21-COA-0180
530 W. Oak St.

Old Louisville Architectural Review Committee
Public Hearing

Kat Groskreutz, Planning & Design Coordinator
September 7, 2022

Site Photos

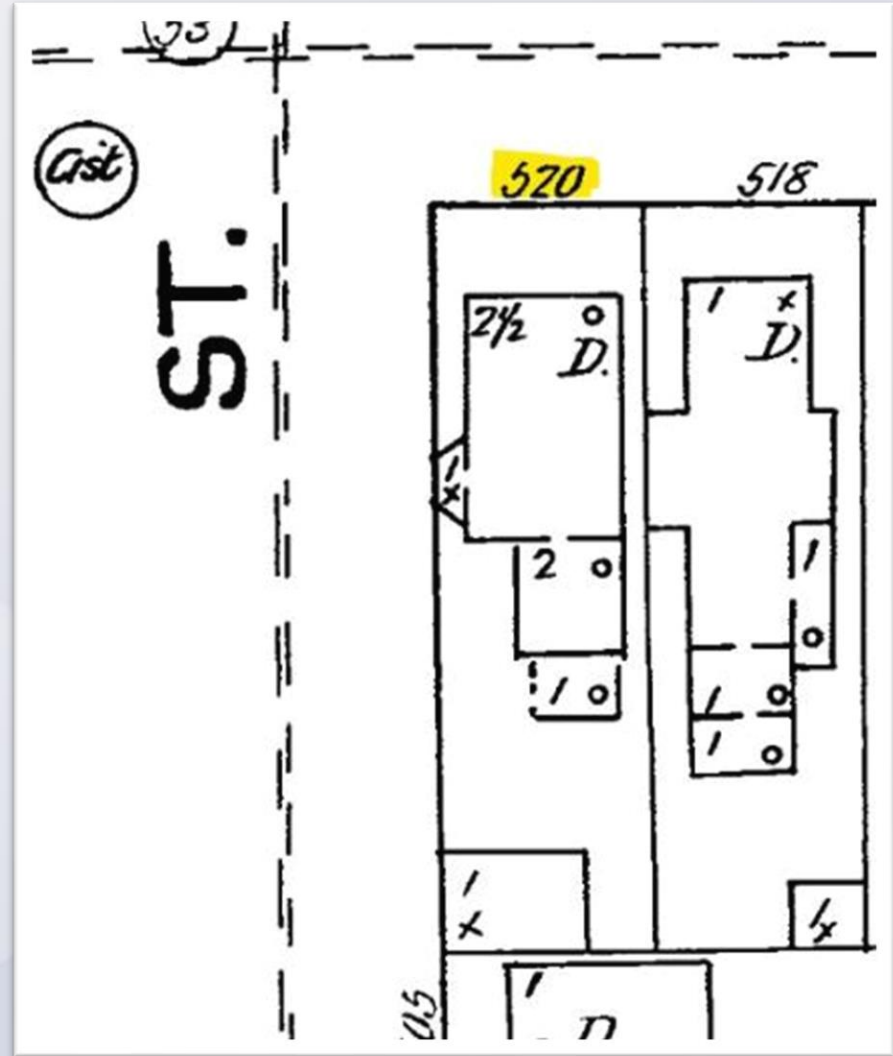
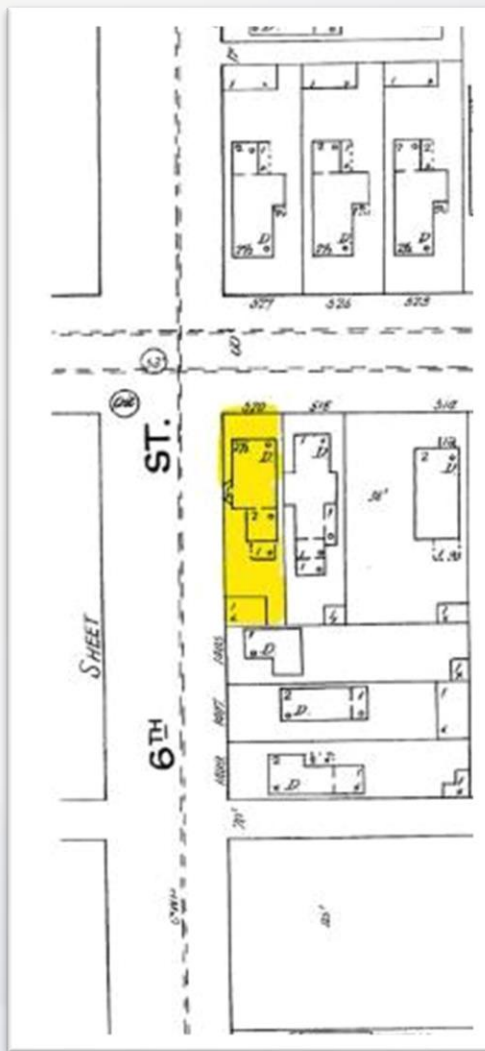
- **Certificate of Appropriateness:** requesting approval for after-the-fact painting of a previously unpainted brick storefront façade
- Current grey paint is primer only; applicant plans on a warm red tone to match existing historic brick
- Applicant wishes for paint to be a stop-gap for continued maintenance issues as he works towards a larger renovation of the storefront façade

- The property is zoned TNZD and is within the Traditional Neighborhood Form District
- The structure was originally a 2.5-story single-family residence. It contains multiple additions, and a storefront was added to the front which was later filled in sometime in the mid-20th century.
- This façade continues to be tagged with graffiti; the continued spray paint and cleaning had damaged the glazed brick surface

- On the basis of the information furnished by the applicant, staff recommends that the request for painting the front storefront façade be **approved with the following conditions:**
 1. The applicant shall work with staff to finalize a color that closely matches the color of the existing historic red brick.
 2. The applicant shall use a "breathable" masonry paint that is compatible with and can create a strong bond with existing primer.
 3. The applicant shall apply for any further changes to the exterior of the building and site prior to any work taking place.
